STATE OF CONNECTICUT
CONNECTICUT SITING COUNCIL

DOCKET NO. 388

AT&T RESPONSES TO
SITING COUNCIL QUESTIONS DATED MAY 17, 2010

Northeast Utilities Services Co.
 CONNECTICUT LIGHT & POWER CO.
 PROJECT NO. 27 - GLEN LAKE
 115-KV LINE #1640 WEST #1610 EAST

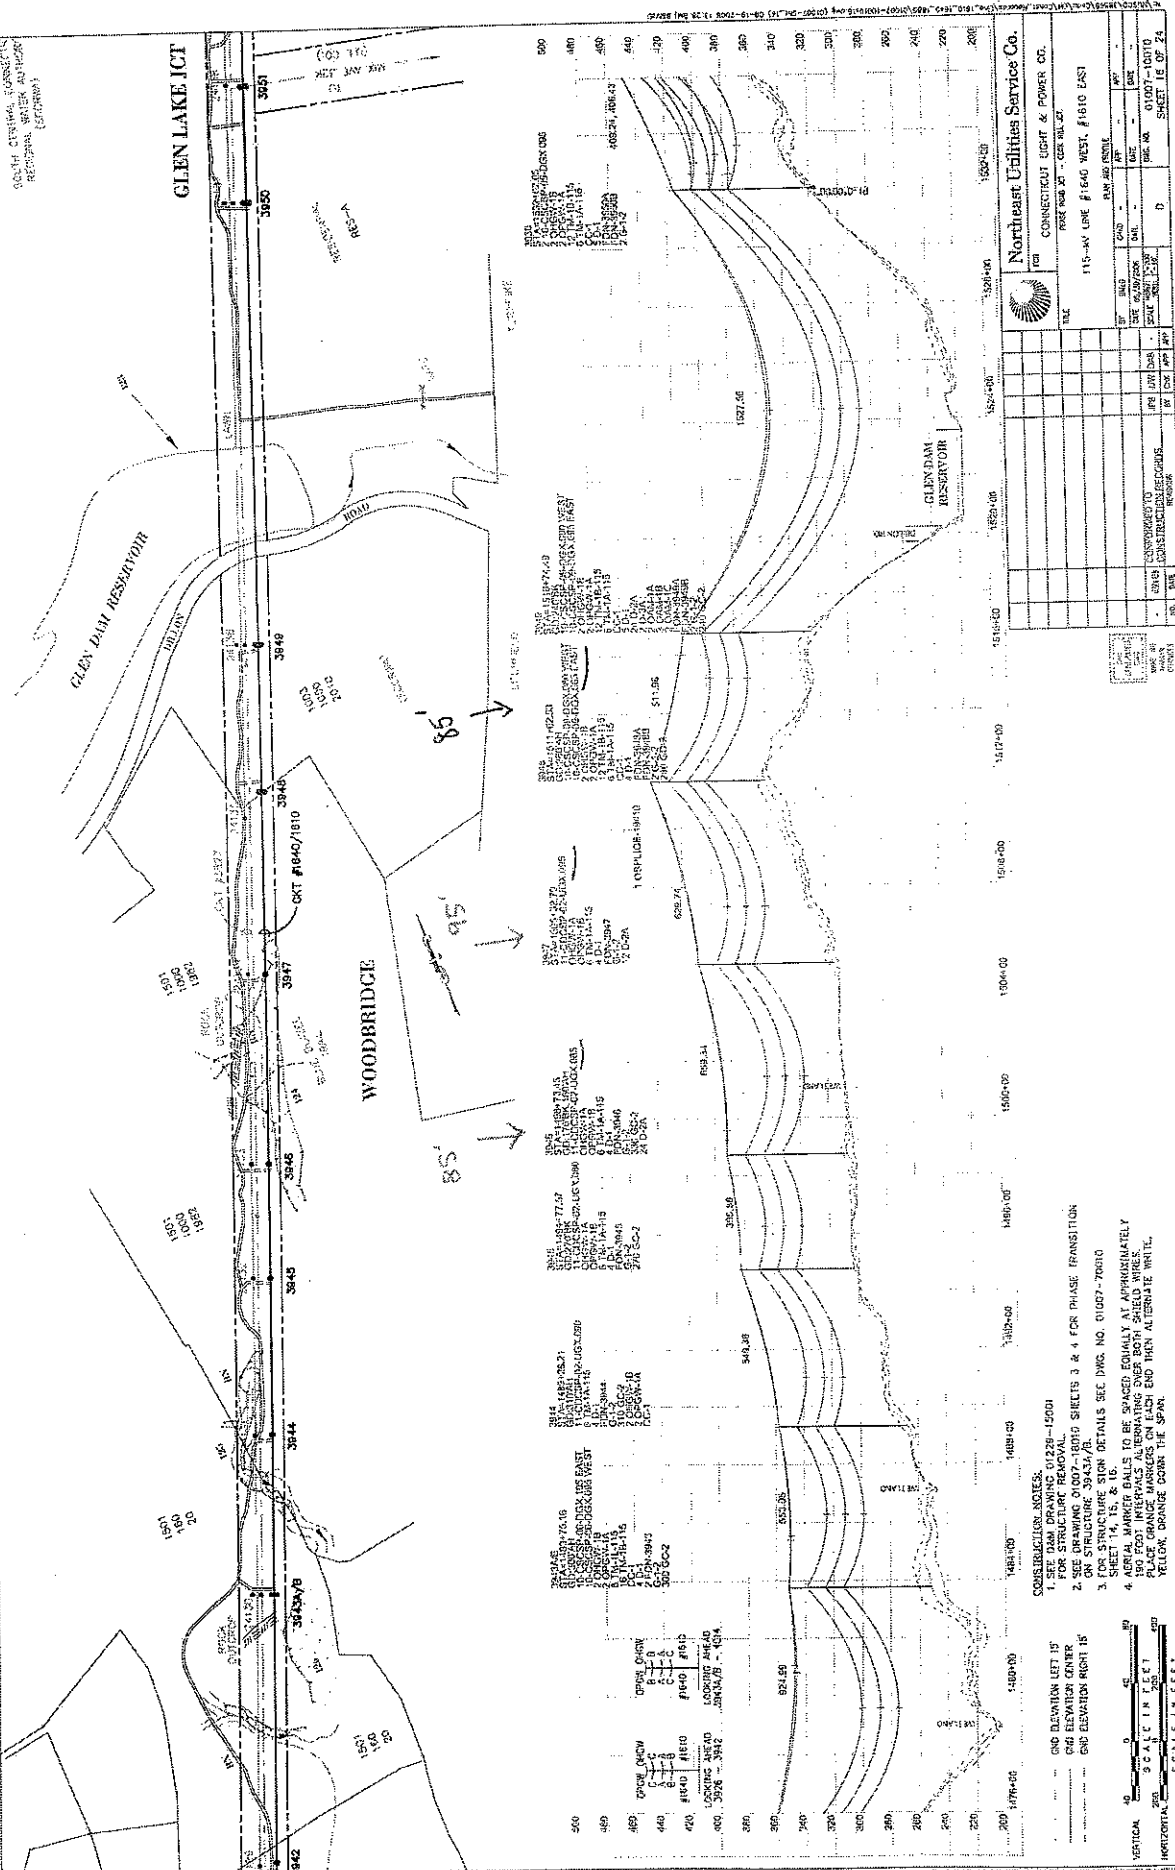
- Q1. Has New Cingular Wireless PCS, LLC (AT&T) evaluated all Connecticut Light and Power Company (CL&P) transmission lines in the vicinity of the proposed tower site for possible co-location in order to meet its coverage objectives? Explain. Also indicate which lines were evaluated and provide the line numbers.

- A1. Yes, CL&P lines in close proximity to the AT&T tower proposal were investigated by AT&T at several distinct times including the Spring of 2008, Fall of 2009 and Winter of 2010 with information sought from CL&P along the way. The line numbers are 3827 and 1640 (which is believed to include 1640 and 1685 115kv circuits) which are 345kv and 115kv lines. Page 22 of the Council's Findings of Fact in Docket 272 indicate that the typical height of the support structures for these lines are at 80 and 85 feet on average with heights up to 123 feet. AT&T's investigation included a walk of the right-of-way ("ROW"), review of the lines and consideration of several poles along these lines as noted in the map attached and other materials in the Application.

Subsequent to the Council's issuance of its May 17, 2010 interrogatories, AT&T consultants and radiofrequency engineers conducted another analysis of the CL&P lines. This included another walk of the ROW, communication with CL&P and further review by AT&T radiofrequency engineers. AT&T was provided with a copy of the CL&P as-builts for the 115kv pole line in the immediate vicinity of the AT&T proposed tower, a copy of which as marked is attached. As noted, the poles in this area are 80' to 95' in height. As part of its radiofrequency analysis that included several of the 115kv poles shown in the attached map, AT&T again concluded that at heights up to that which would be considered co-location (i.e. 20' attachment to the existing structure), the CL&P lines could not fully meet its coverage objectives. Coverage to the west and along Route 63 was insufficient at these heights.
